SERVICE BULLETIN

SERVICE BULLETIN		NO.: MSB-97E11-502	
		DATE: 1997-02-28	<MODEL> ECLIPSE(D30) 96-10 CARISMA 96-10
SUBJECT: CHANGE IN LASH ADJUSTER CHECKING PROCEDURE			
GROUP: ENGINE		DRAFTNO.: 96-AL-504	
CORRECTION	OVERSEAS SERVICE DEPT	 R. USAMI - MANAGER QUALITY INFORMATION ANALYSIS

The lash adjuster checking procedure has been changed as follows:

In-line 4-cylinder engine (W-E) – Except Carisma

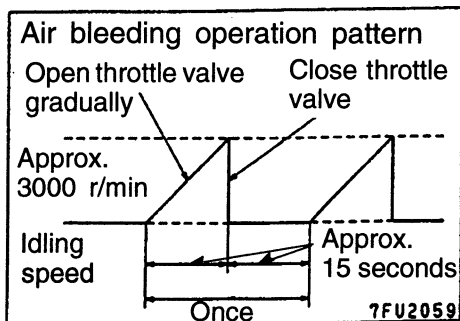
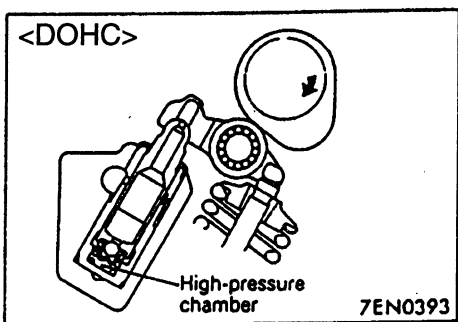
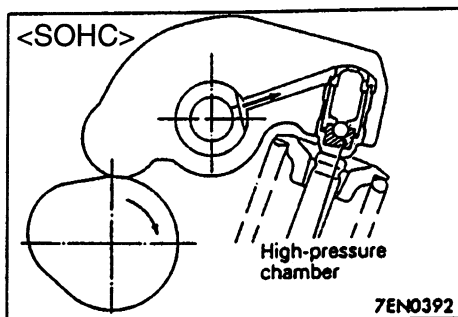
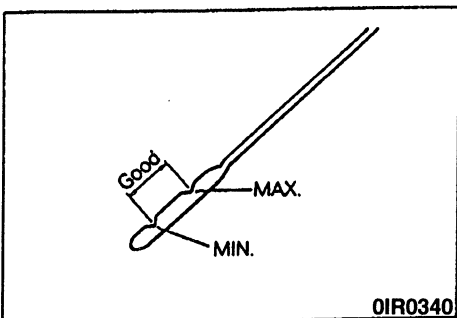
- (1) Stop the engine.
- (2) Remove the rocker cover.
- (3) Set the piston in No.1 cylinder at top dead center of the compression stroke.
- (4) Check the rocker arms indicated by a white arrow in the figure next page by the following procedure.

- 1) Check if a 0.1 – 0.2 mm leaf of the feeler gauge can be inserted between the valve and the lash adjuster.
 - 2) Record the corresponding lash adjuster as a defective if the leaf of the feeler gauge can be inserted easily.
 - 3) If the feeler gauge leaf cannot be inserted easily, the lash adjuster is in good condition. Therefore, investigate other cause of the abnormal noise.
- (5) Slowly turn the crankshaft 360° clockwise.
 - (6) Follow the same procedure as step (4) to check the rocker arms indicated by a black arrow in the figure next page.
